## NOTICE OF DECISION

**URBAN GROWTH AREA PRELIMINARY DECLARATION / CLASS 3 SITE PLAN REVIEW / CLASS 2 DRIVEWAY APPROACH PERMIT CASE NO. UGA-SPR-DAP17-02**

**APPLICATION NO. : 17-106030-LD & 17-106031-RP**

**LOCATION:** 2300 Block of McGilchrist Street SE / 97302

1 SITE PLAN  
0' 4' 8' 16' 24' 48' 1/16" = 1'-0"

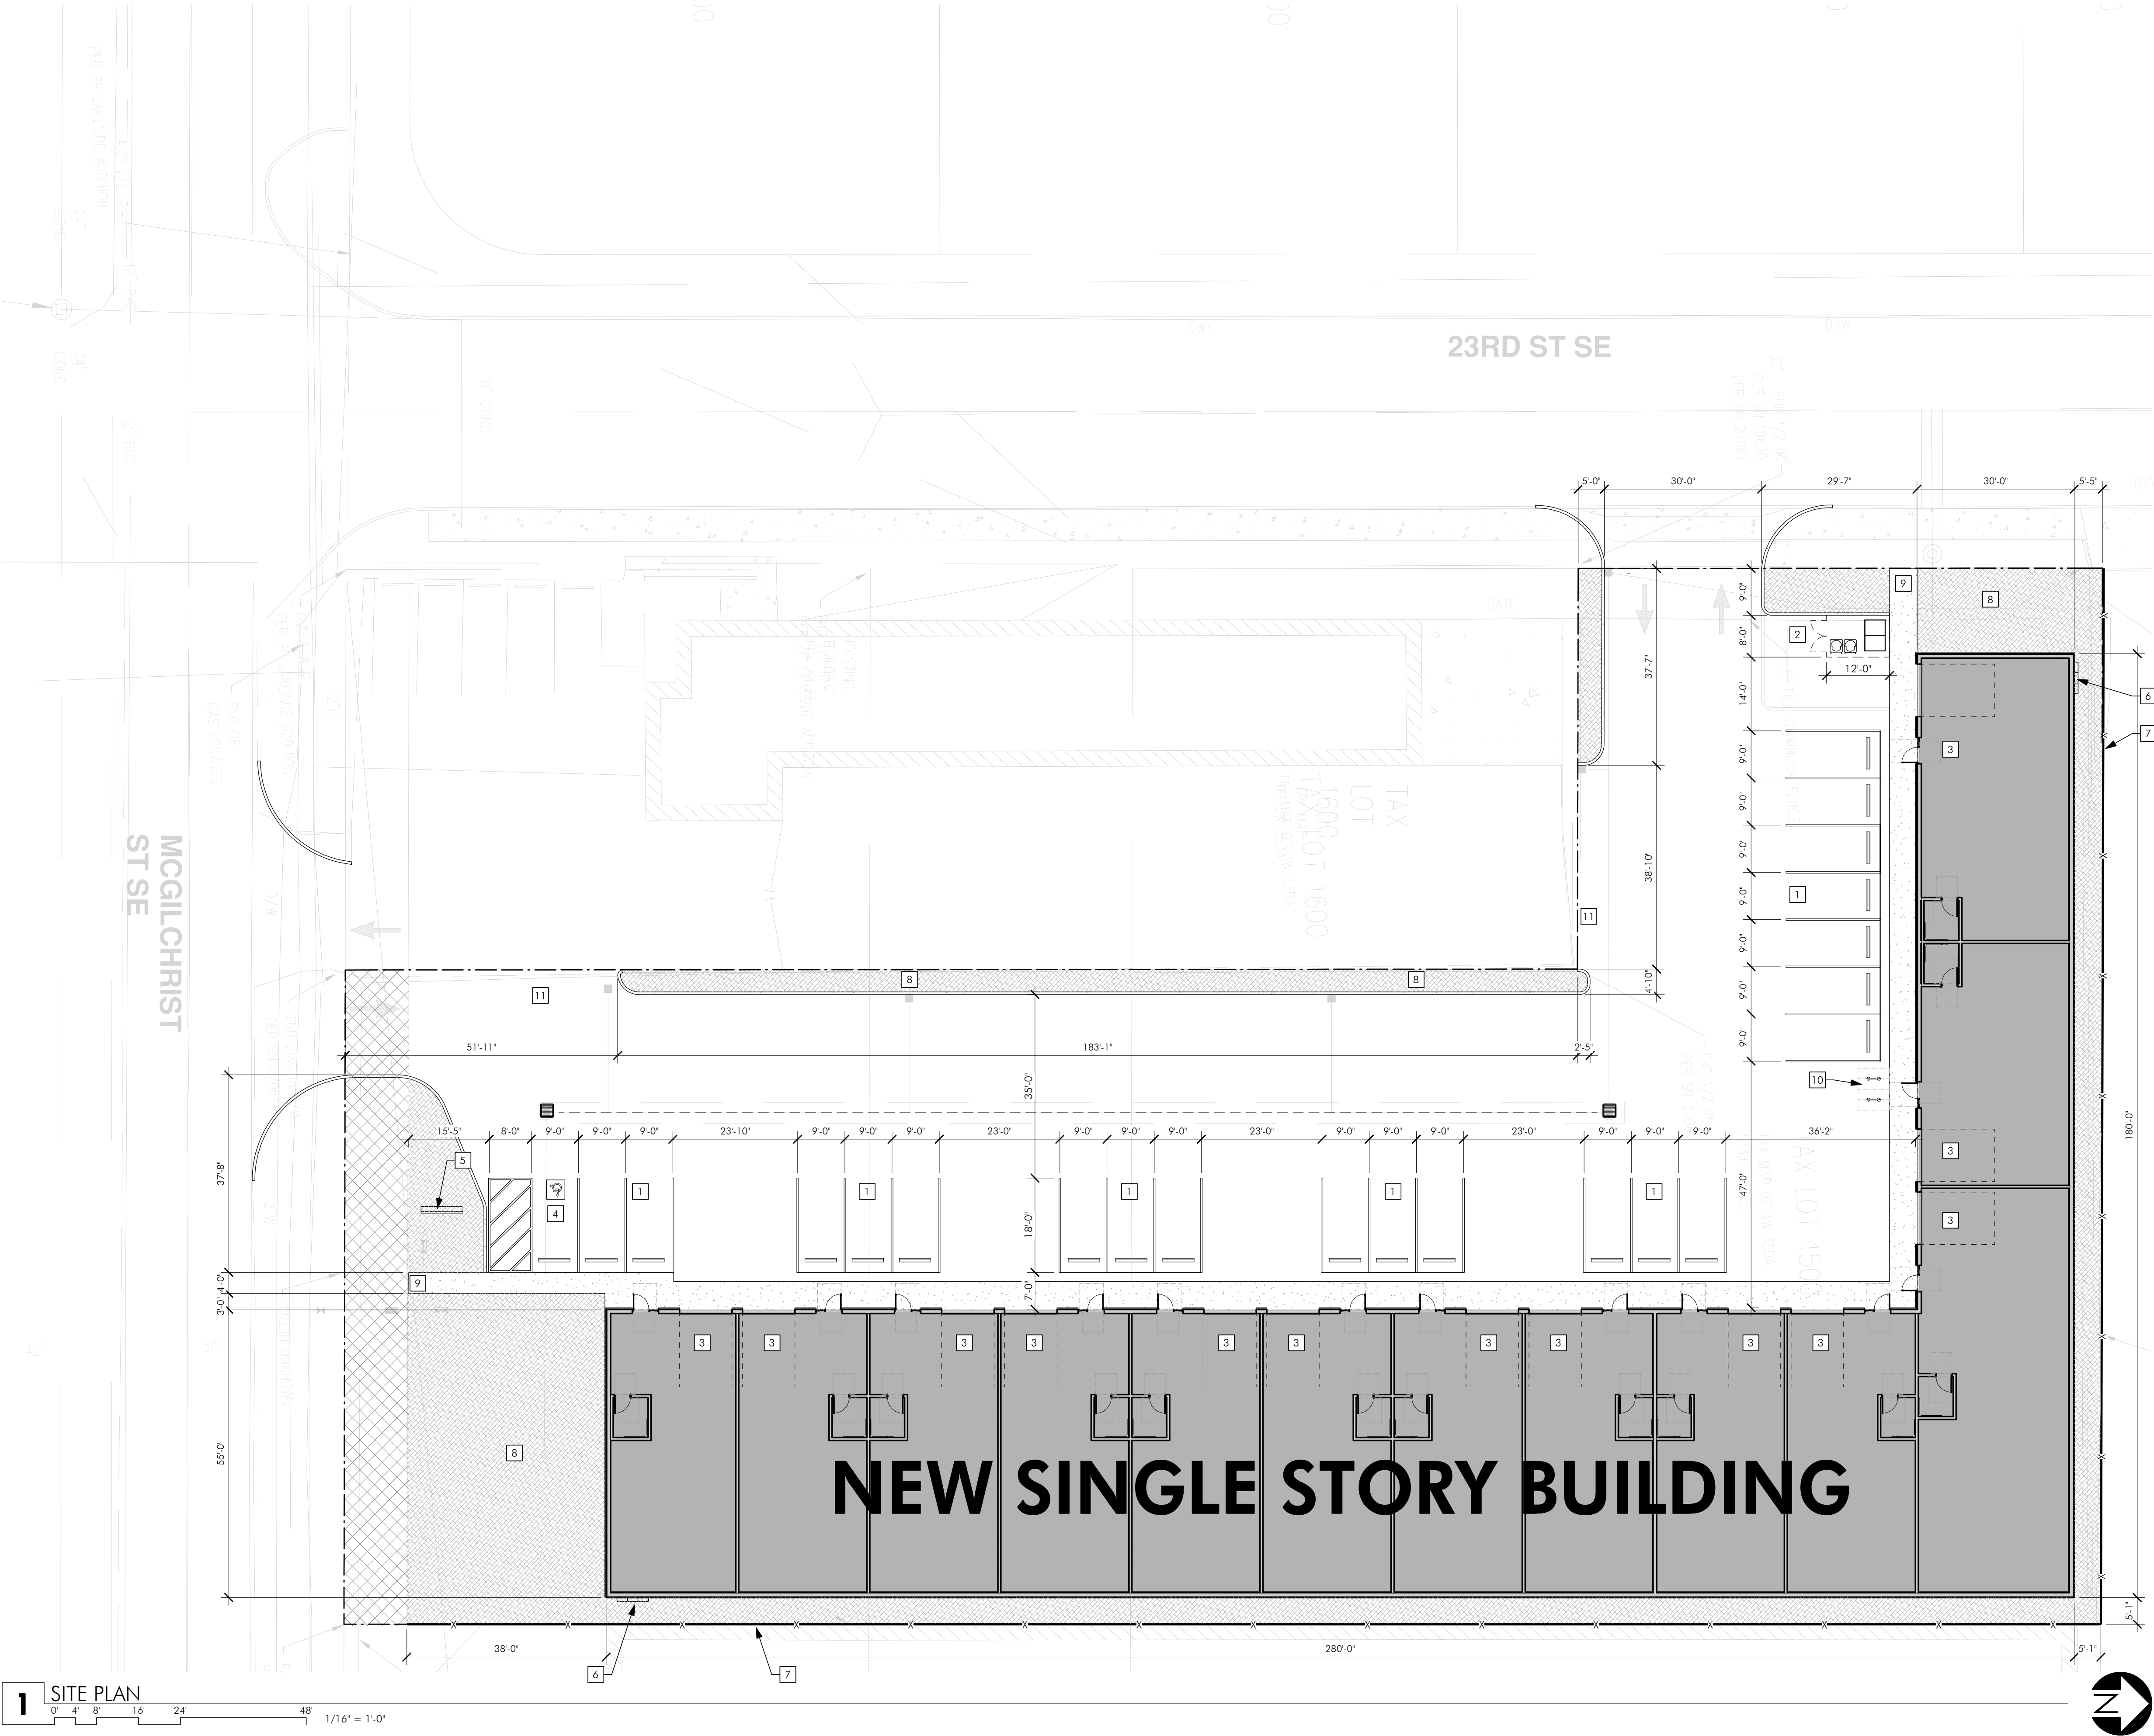
The applicant's site plan proposes curblin sidewalk along the development frontage of 23rd Street SE. Pursuant to SRC 803.035(l), sidewalks are to be located one foot from the adjacent right-of-way property line unless topography or other conditions make the construction of sidewalk impossible or undesirable. At the time of construction of 23rd Street SE, curblin sidewalk was anticipated and power poles were installed in a location that would not conflict with construction of a curblin sidewalk. Based on existing development constraints, staff has determined a curblin sidewalk is appropriate along 23rd Street SE per SRC 803.035(l)(2)(B) and SRC 803.065. As a condition of approval, up to two additional street lights will be required along 23rd Street SE under the prescriptive spacing standards described in PWDS. The required streets lights can be located on existing power poles.

**Finding:** The proposed building has a floor area of approximately 20,000 square feet in size, requiring a minimum of 13 off-street parking spaces ( $20,000 / 1,500 = 13.3$ ). The maximum off-street parking is 33 parking spaces ( $13 \times 2.5 = 32.5$ ). The site plan indicates there are 22 parking spaces within the vehicle use area.

**Finding:** The proposed site plan indicates that the off-street parking area is approximately 20,336 square feet in size, requiring a minimum of 1,017 square feet of interior parking lot landscaping. Approximately 2,600 square feet of parking lot landscape area is proposed, exceeding the minimum requirement.

**Staff Response:** The width of the front opening of the proposed enclosure is approximately 6 feet wide.

**Staff Response:** The proposal includes 12 inches from the inside of the enclosure wall to the receptacles. Compliance will be verified at building permit. The following condition is required to meet the standard:

**Condition 2:** Along the extent of abutting improvements of 23rd St SE as defined in SRC 200.035(a)(4), the applicant shall construct the incomplete portion of the half street improvement between the curb line and the right-of-way line, including construction of sidewalk, street trees, and street lights as specified in PWDS. The sidewalk along 23rd may be constructed along the curb line or property line and the required street lights may be located on existing power poles.

**Condition 3:** Provide an unobstructed front opening of at least 12 feet in width for each enclosure.

**Condition 4:** Provide minimum 4-inch nominal high bumper curb at ground level located 12 inches inside the perimeter of the outside walls of the enclosure, or a fixed bumper rail.

**Condition 5:** Provide gates that swing a minimum of 120 degrees and provide restrainers in the open and closed positions.
